Development Services

APPEAL SUMMARY

Appeal ID: 23422	Project Address: 10101 NE Alderwood Rd
Hearing Date: 2/5/20	Appellant Name: Ryan Weston
Case No.: B-015	Appellant Phone: 503-224-9560
Appeal Type: Building	Plans Examiner/Inspector: Jeff Donnelly
Project Type: commercial	Stories: 1 Occupancy: S-1, F-1, B Construction Type: V-B
Building/Business Name: Eyelevel	Fire Sprinklers: Yes - Entire Space
Appeal Involves: Reconsideration of appeal	LUR or Permit Application No.:
Plan Submitted Option: pdf [File 1] [File 2]	Proposed use: Warehouse and Fabrication

SHEET TITLE:
OCCUPANCY
AND PLUMBING
FIXTURE
EXHIBIT

Original proposed floor plan

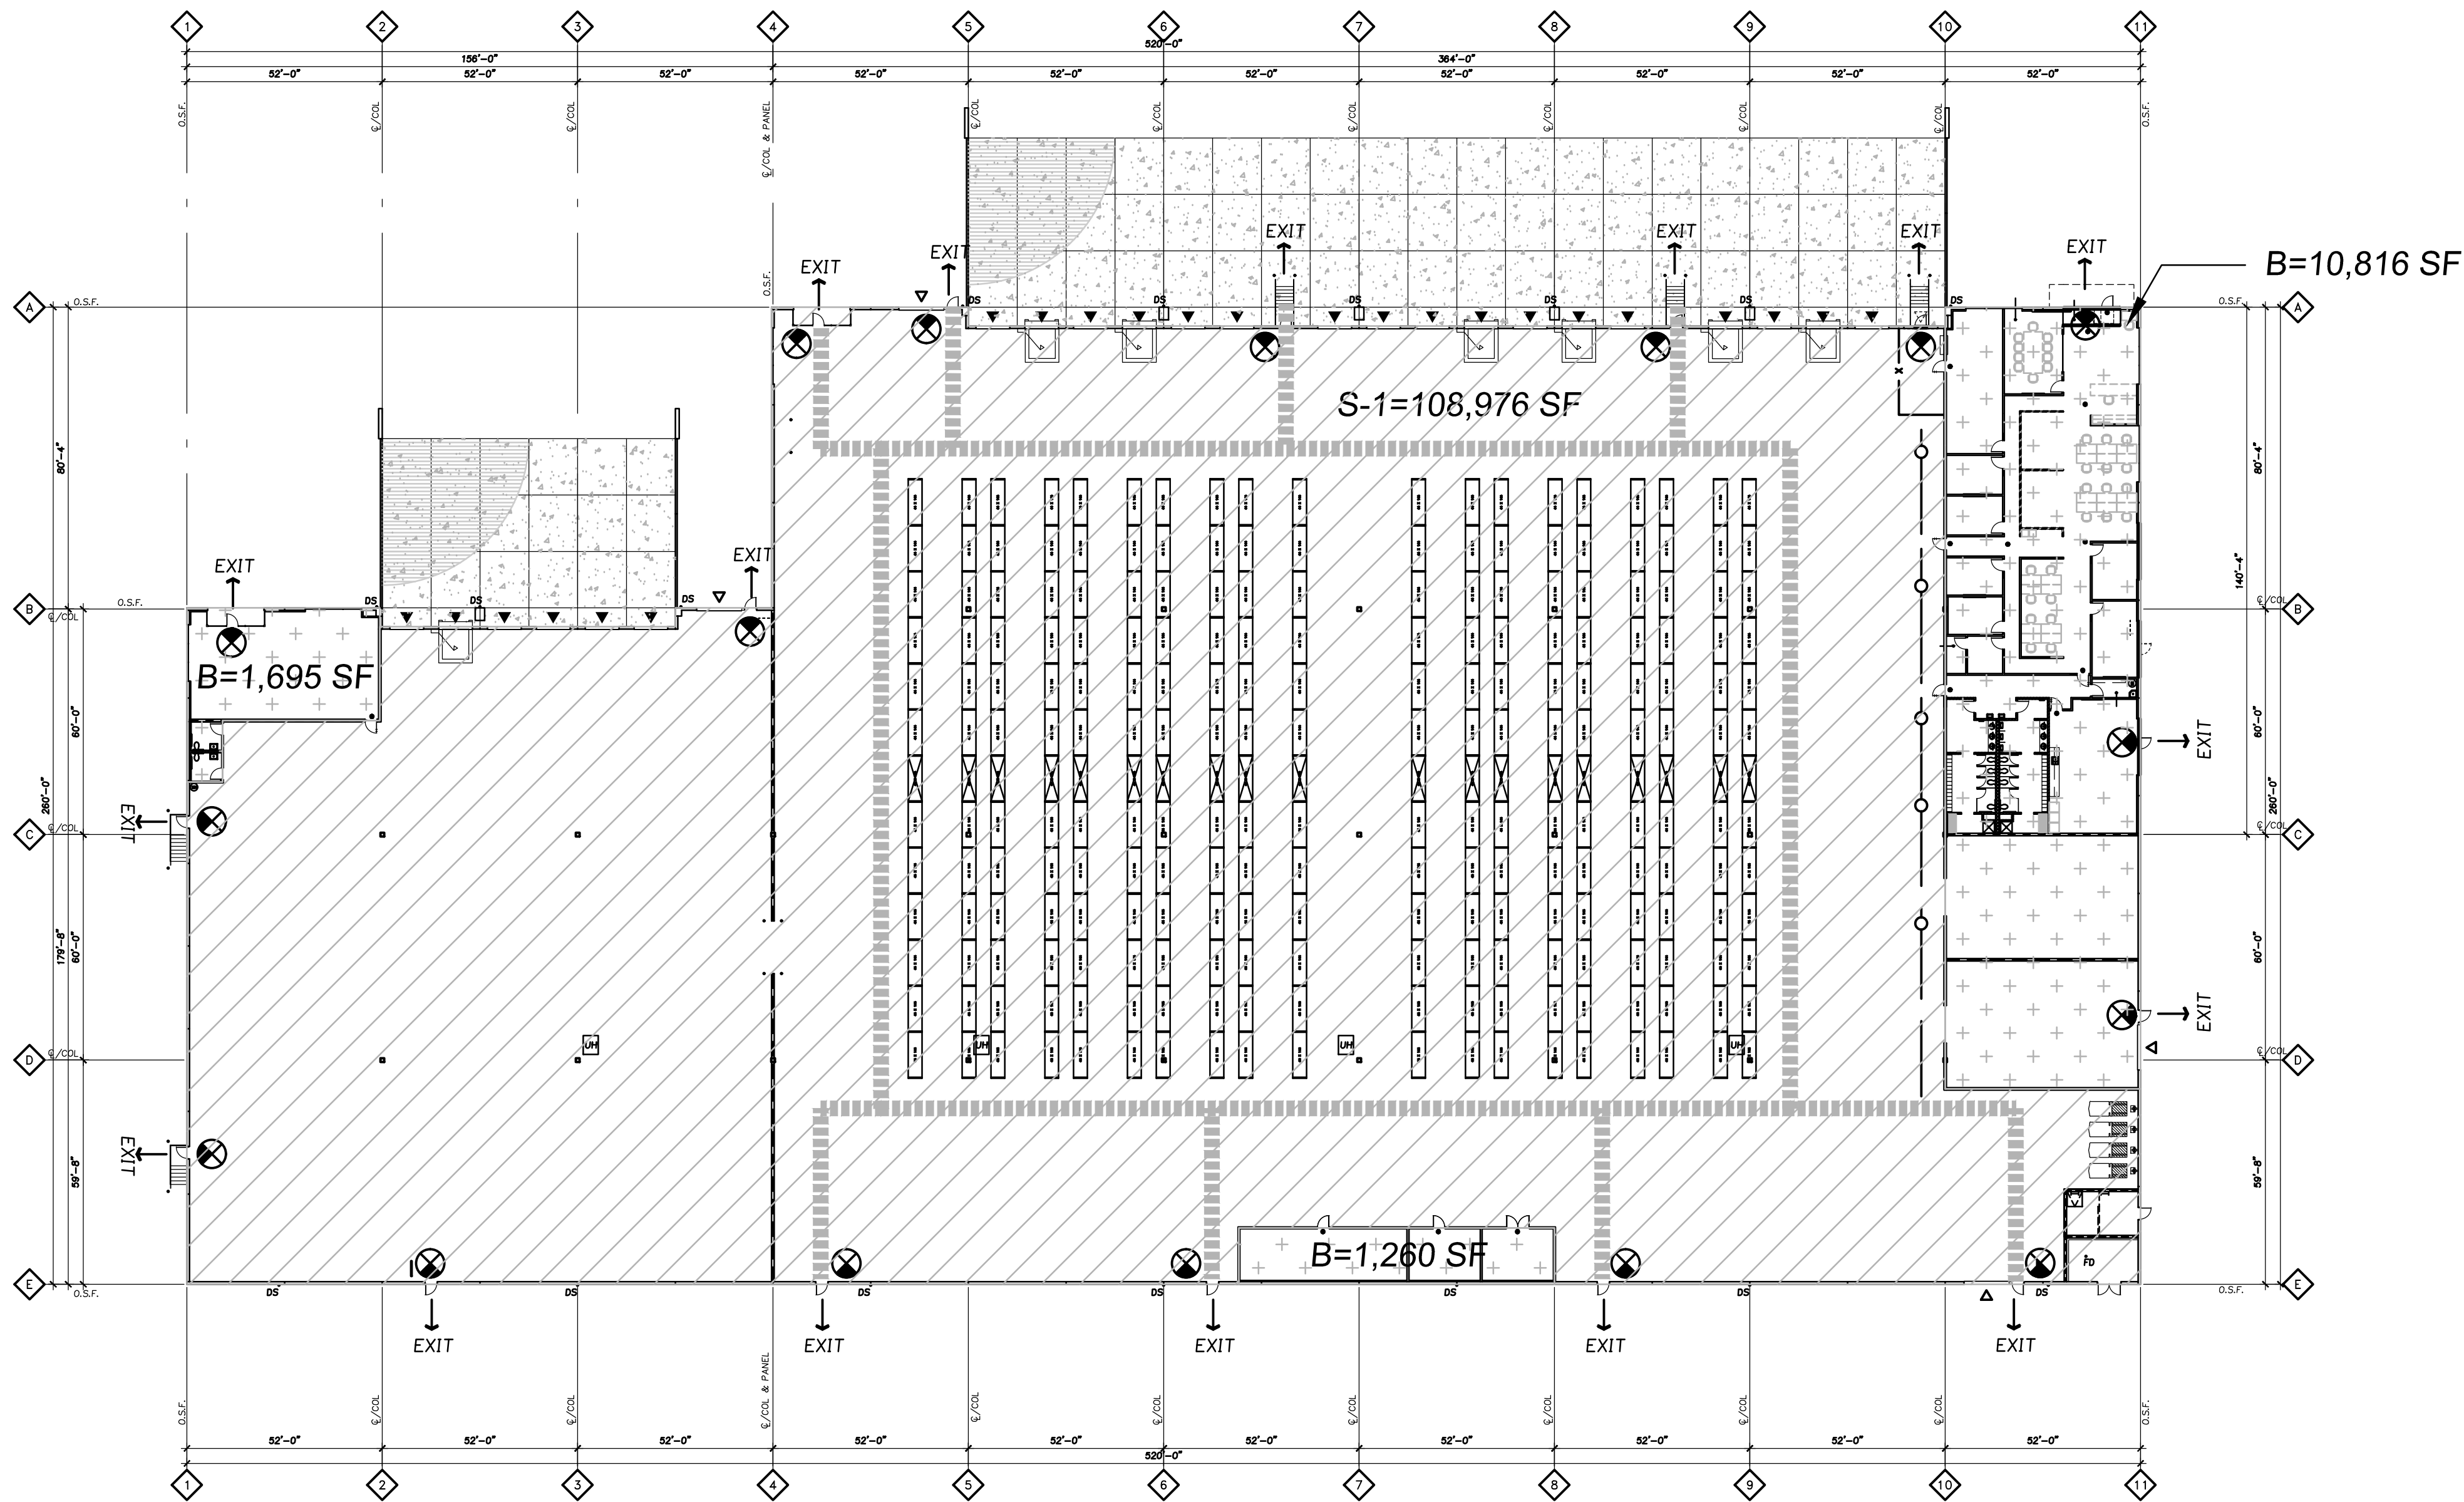
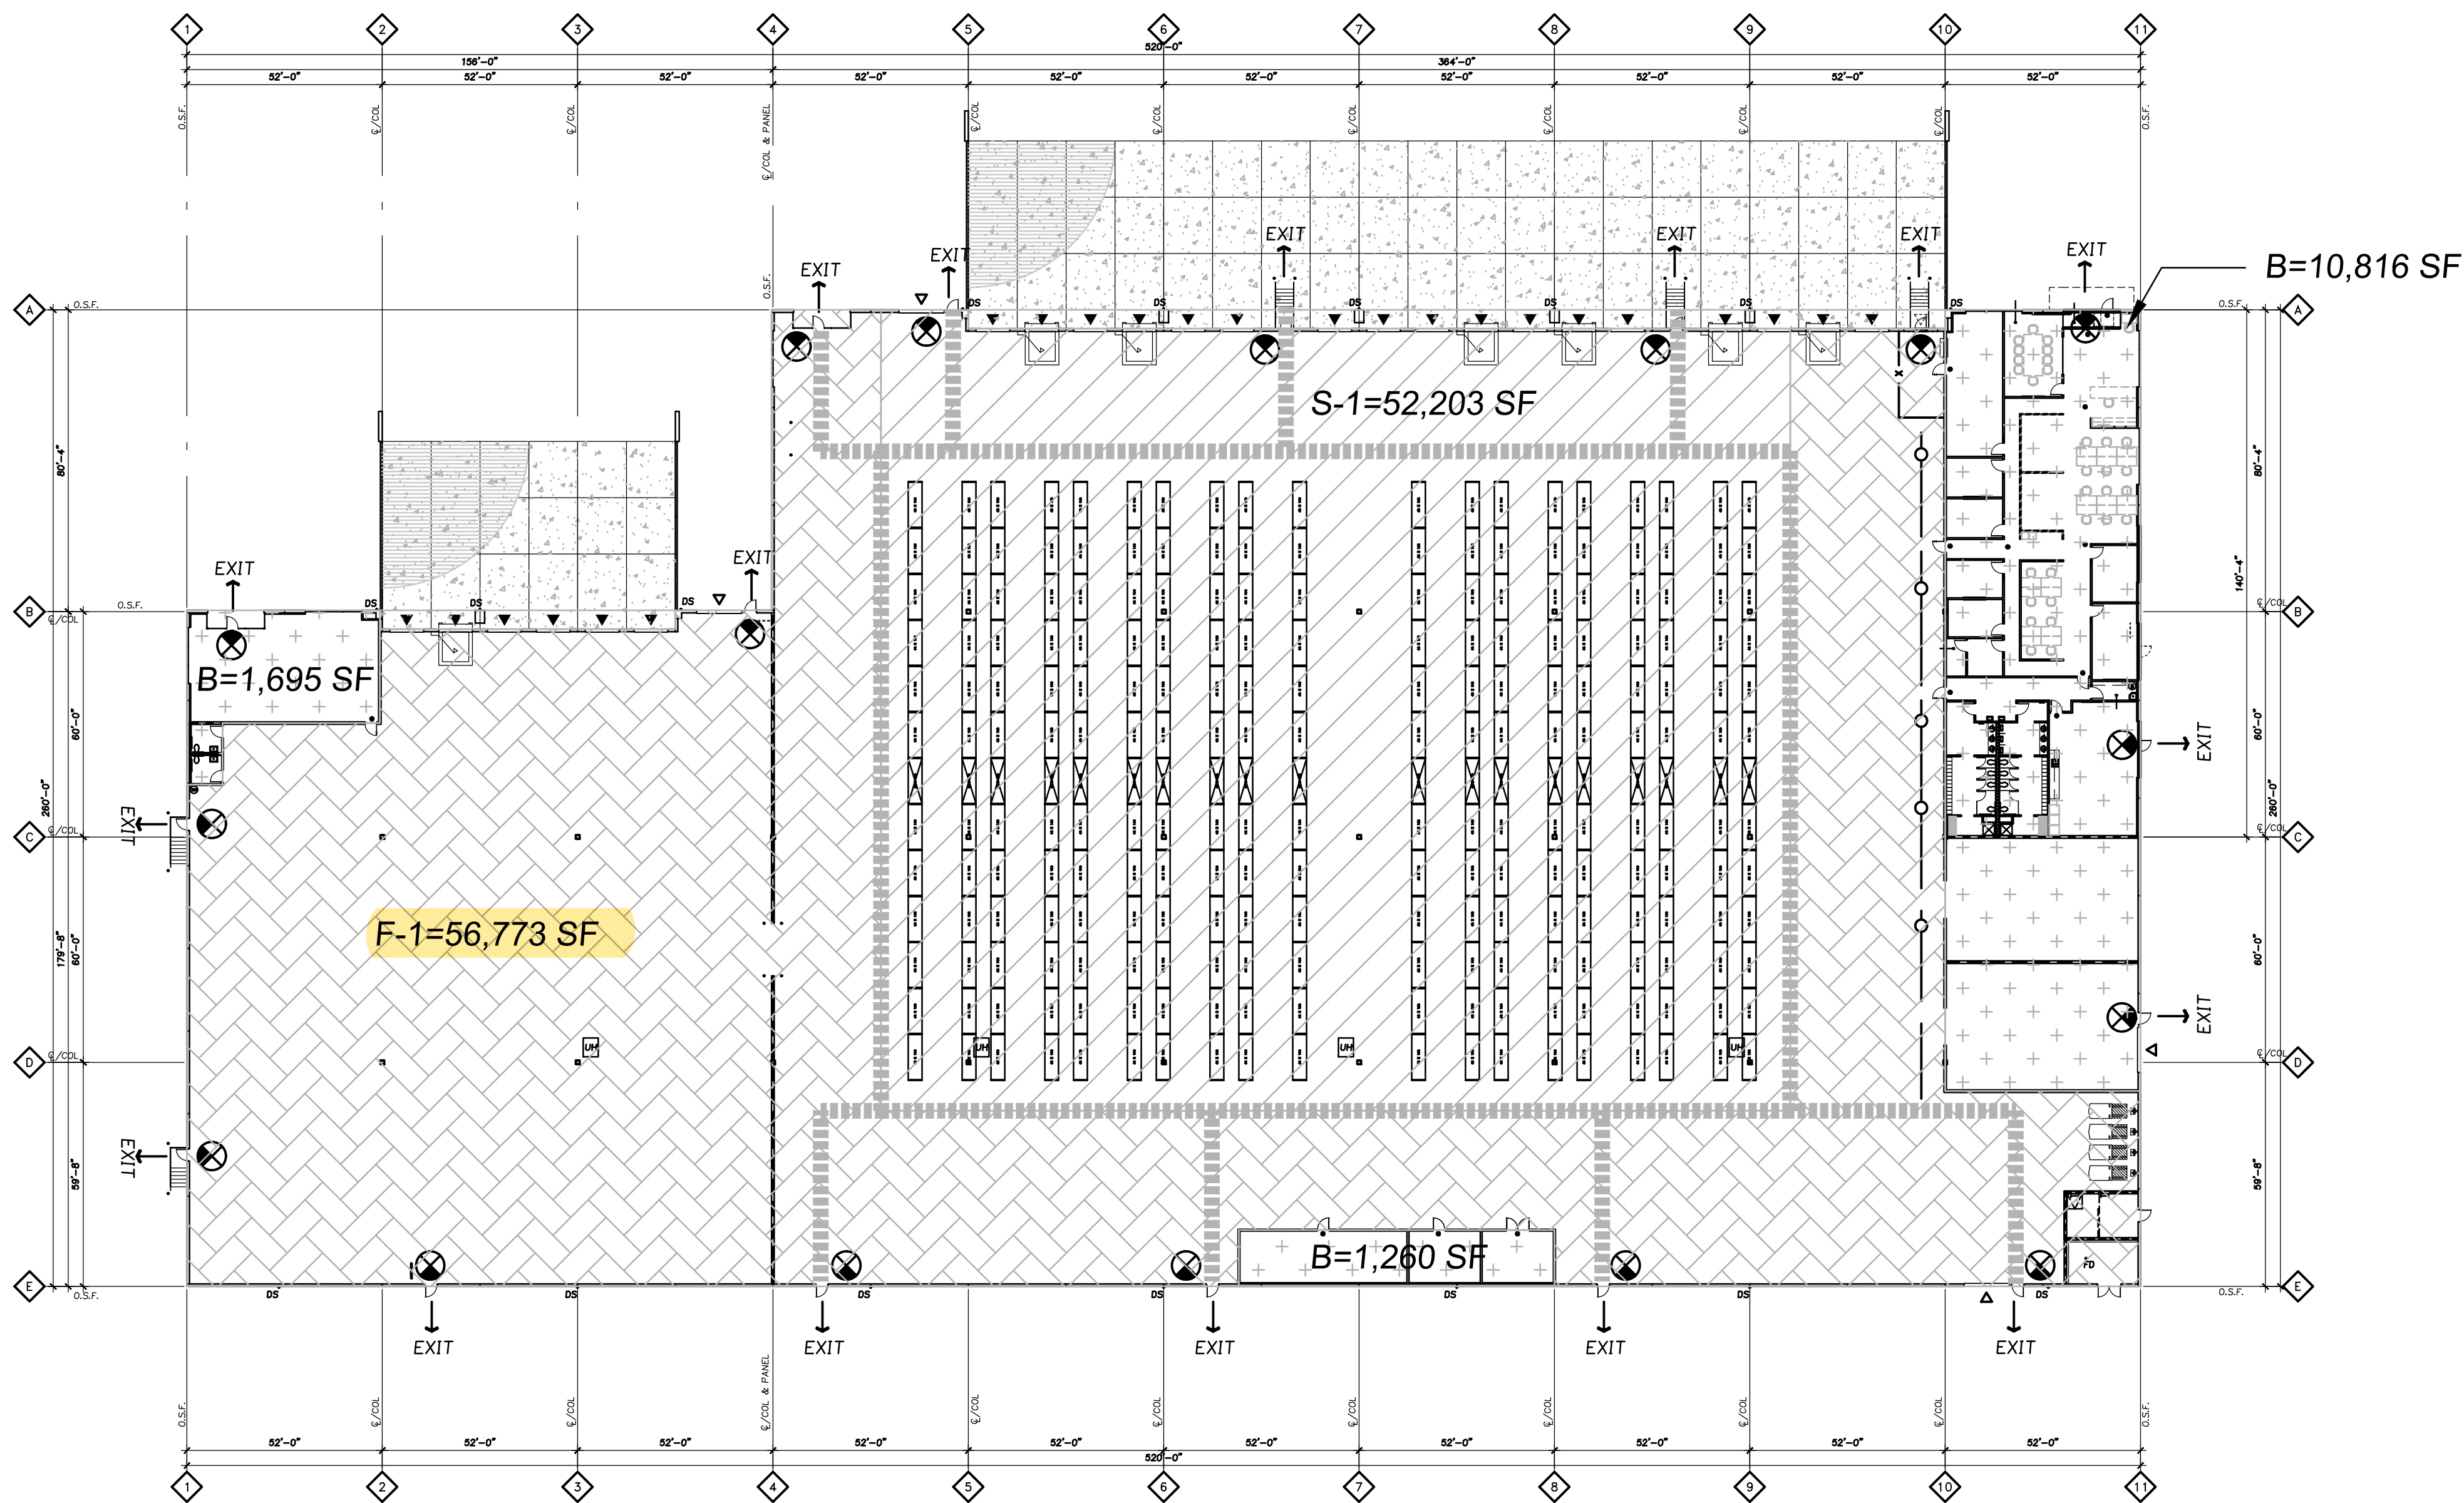
Code Section	2902.1.1
Requires	<p>Provide minimum plumbing fixtures per table 2902.1 based on occupancy of space.</p> <p>B occupancy - 13,771 SF</p> <p>S-1 occupancy - 52,203 SF</p> <p>F-1 occupancy - 56,773 SF</p> <p>B occupancy (138 occupant load) - 2.38 water closets per sex and 1.73 lavatories per sex</p> <p>F-1 occupancy (568 occupant load) - 2.84 water closets per sex and 2.84 lavatories per sex</p> <p>S-1 occupancy (105 occupant load) - 0.53 water closets per sex and 0.53 lavatories per sex</p> <p>Total required fixtures: 6 water closets per sex and 6 lavatories per sex.</p> <p>Reconsideration Text:</p> <p>B occupancy 10,252 SF (103 occupant load) - 2.03 water closets per sex and 1.29 lavs' per sex</p> <p>F-1 occupancy 41,063 SF (411 occupant load) - 2.06 water closets per sex and 2.06 lavs' per sex</p> <p>S-1 occupancy 71,432 SF (143 occupant load) - 0.72 water closets per sex and 0.72 lavs' per sex</p> <p>Total required fixtures: 5 water closets per sex and 5 lavatories per sex.</p>

Code Modification or Alternate Requested	We would like to propose a higher occupant load factor for the F-1 area in lieu of excluding it from the plumbing fixture counts.
Proposed Design	<p>Base the plumbing calculations on occupancy noted below.</p> <p>B occupancy - 13,771 SF</p> <p>S-1 occupancy - 108,976 SF</p>

B occupancy (138 occupant load) - 2.38 water closets per sex and 1.73 lavatories per sex.
S-1 occupancy (218 occupant load) - 1.09 water closets per sex and 1.09 lavatories per sex.

Total fixtures required: 4 water closets per sex and 3 lavatories per sex.

Reason for alternative The tenant has noted that their occupancy will have some fabrication and will be going through a permitting process to update their occupancy classification. They however only have 85 total employees within two shifts and as such do not feel they need additional plumbing fixtures to accommodate those employees. Their existing space already has 8 men's water closets/urinals with 4 lavatories and 5 women's water closets with 4 lavatories.

Based on the actual employee count they are well below the occupant load for their existing occupancy and proposed occupant load factors. The proposed occupancies would require the tenant to add 1 female water closet and 2 each, male and female lavatories.

Reduction in minimum required number of plumbing fixtures: Granted as proposed.
